**Valentine Gold Project: Second
Amendment to the EIS**

Second Amendment to the
Environmental Impact Statement

Marathon Gold Corporation
36 Lombard Street, Suite 600
Toronto, ON M5C 2X3

January 7, 2022

Figure HC(2)-09.1 NO₂ Maximum Predicted Annual Concentration including Background (Regulatory Limit 100 µg/m³)

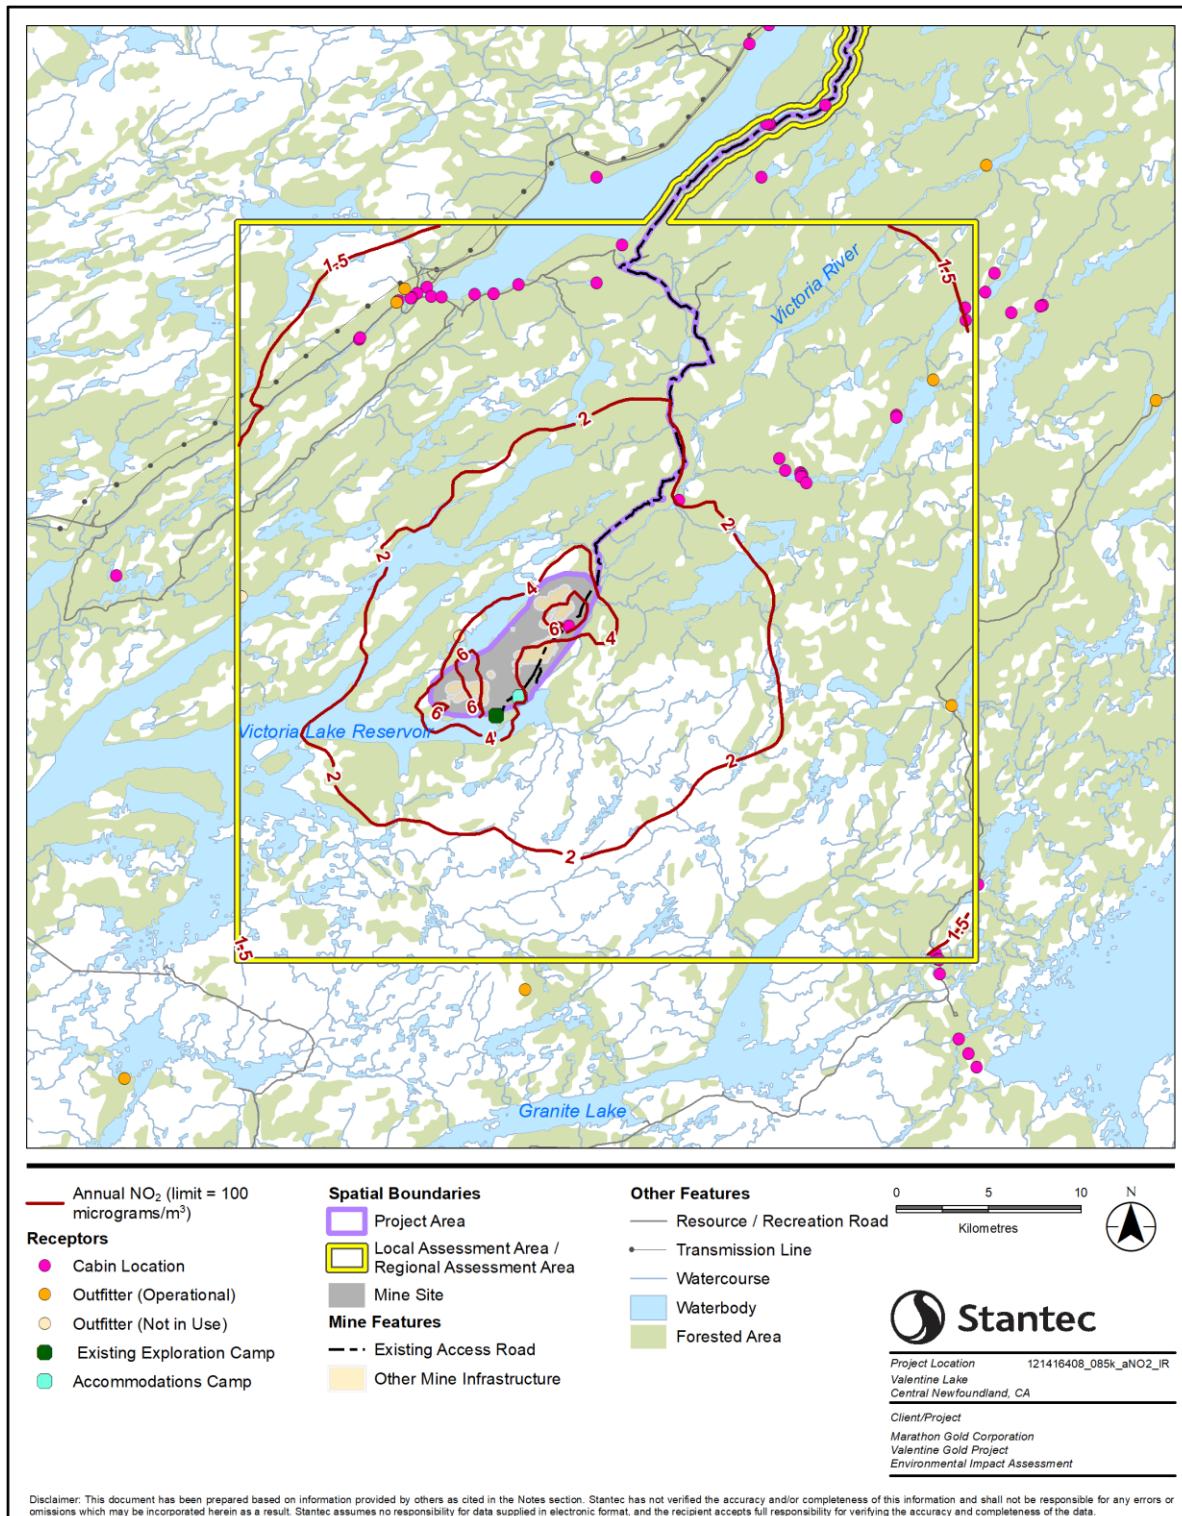
IR 2 Reference #	HC(2)-09
IR 1 Reference #	HC-14
EIS Reference:	-
Context and Rationale:	<p>The contour maps do not provide predicted levels of certain air contaminants.</p> <p>The contour maps in Figures HC 14.10 to 14 (EIS Amendment Response to IR HC-14, pdf p.264 to 268) do not provide annual average concentrations of NO₂ and SO₂.</p>
Information Request:	<p>Health Canada recommends that the Department request the following comments be addressed in an updated EIS:</p> <p>Provide annual average concentrations of NO₂ and SO₂ in relation to the sensitive receptor locations.</p>
